Re: In the Matter of Application to the North Dakota Public Service Commission for a Waiver of Procedures and Timelines, and Consolidated Certificate of Corridor Compatibility and Route Permit, Pillsbury-Fargo Generation Outlet Project. Case Number PU-08-48

Pillsbury to Fargo Generation Outlet Project

Summary of Route Changes

Pillsbury-Fargo Generation Outlet

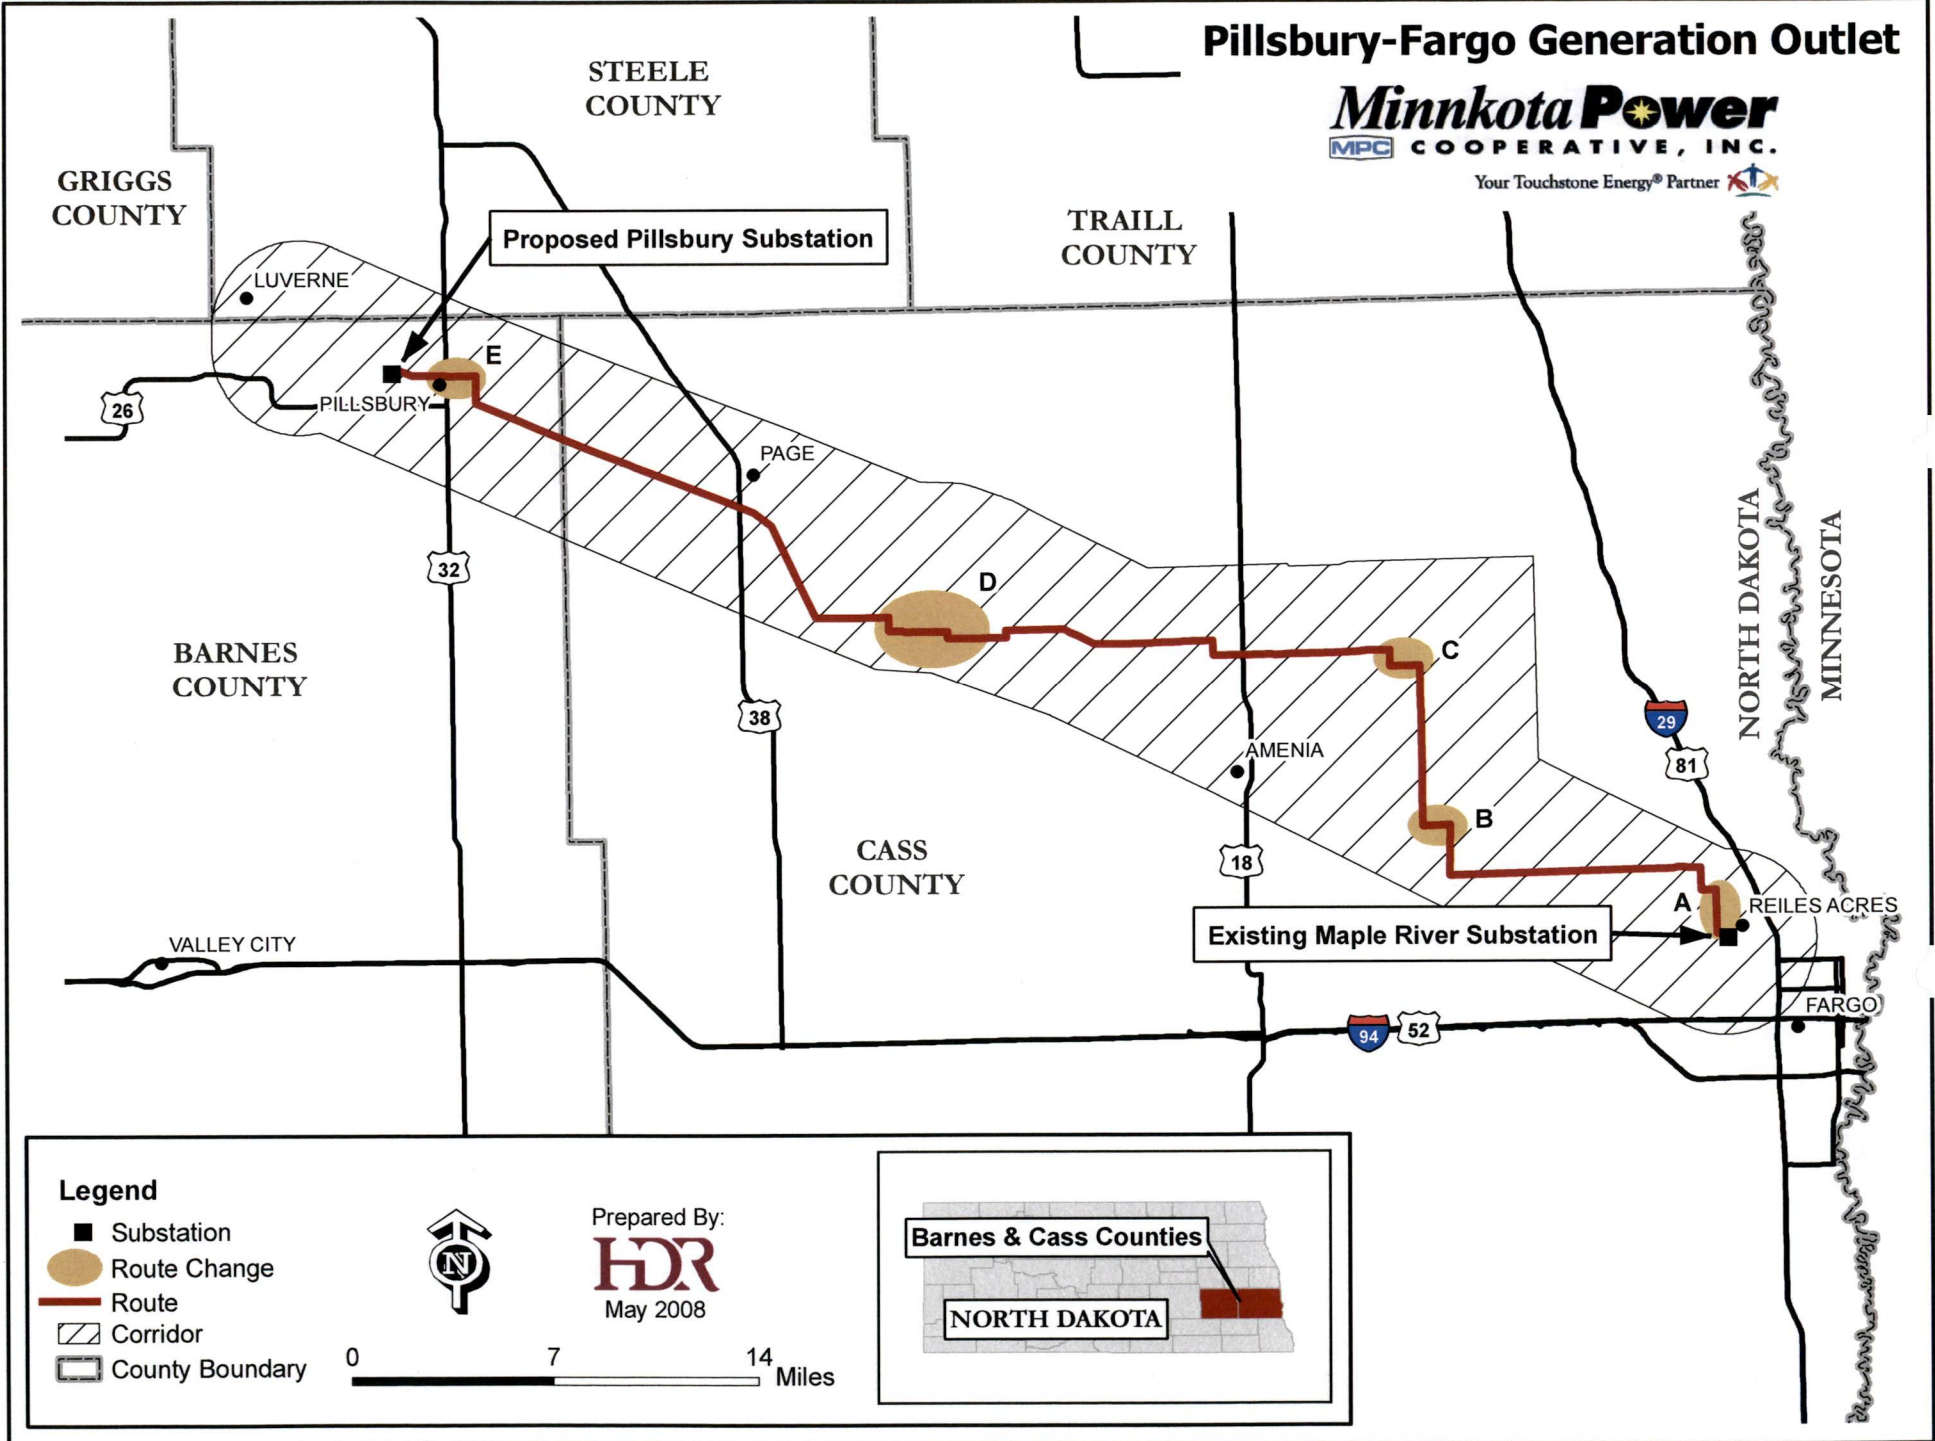
Subsequent to Minnkota's filing of its amended route application dated April 16, 2008 (Amended Route), six route changes were incorporated into the Proposed Final Line Structure Location maps (Final Route) that was filed with the North Dakota Public Service Commission on May 15, 2008. These route change locations are depicted on the attached route change overview map. A summary of these route changes is provided below:

Route Change A – Reed Township (Sections 8, 16 - 17, 21, 28)

Beginning at the Maple River Substation, the Final Route was moved about 0.5 mile west of the Amended Route for about the first 1.5 miles. The Final Route leaves the Maple River substation to the west instead of the north and continues west along an existing 69-kV transmission line owned by Minnkota for about 0.5 mile. At that point it turns to the north along a section line (Section 28), continuing to follow an existing 69-kV transmission line owned by Minnkota. In Section 16, the Final Route returns to the Amended Route alignment.

The Final Route change will require that new structures accommodating both the 230-kV and the 69-kV be installed in place of the single 69-kV structures. The Final Route is also within 500 feet of three occupied structures that were not within 500 feet of the Amended Route. Waivers have been obtained for each of these structures. No other exclusion or avoidance areas are present along the portion of the Final Route change.

Route Change B - Rush River (Section 36) and Harmony (Section 2) Townships

The Final Route shifted slightly from the Amended Route. In particular, the route shifted from just north of the Rush River Section 36 line to just south of the Harmony Section 2 section. No exclusion or avoidance areas are present in the area of the Final Route change.

Route Change C - Rush River (Section 2 - 3)

The Final Route was shifted slightly from the Amended Route. Instead of traversing west, just north of the $\frac{1}{4}$ Section line of Section 2, the Final Route will traverse west, just south of the $\frac{1}{4}$ Section line of Section 2 into Section 3. Just west of the section line (Section 3), the route heads north and connects back into the Amended Route. No exclusion or avoidance areas are present in the area of the Final Route change.

Route Change D - Erie (Section 31, 32, 33) and Rich (Section 25) Townships

The Final Route was shifted across three sections crossed by the Amended Route. In Erie township, instead of traversing north at the section line (Section 33), the Final Route continues into Section 32 and then traverses north to the section line (Section 32). At the section line (Section 32), the route turns west along the northern edge of Section 31 in Erie Township and continues into Section 36 of Rich Township. At the $\frac{1}{4}$ section line, the route crosses the section line into Section 25 and continues west into Section 26. Just

west of the section line (Section 26), the route turns north and connects back into the Amended Route. No exclusion or avoidance areas are present in the area of the Final Route change.

Route Change E - Ellsburry Township (Section 16)

The Final Route was shifted slightly from the Amended Route. Instead of crossing the southern edge of Section 9, the Final Route will cross the northern edge of Section 16. The Final Route is now within 500 feet of one occupied structure that was not within 500 feet of the Amended Route. A waiver has been obtained for this structure. The Final Route also crosses over USFWS wetland easements located in Section 16; however, no poles will be placed within easement boundaries. The USFWS has been consulted and has confirmed that no USFWS compatibility analysis or right-of-way permit will be required for the Final Route and pole locations. No other exclusion or avoidance areas are present along the portion of the Final Route change.
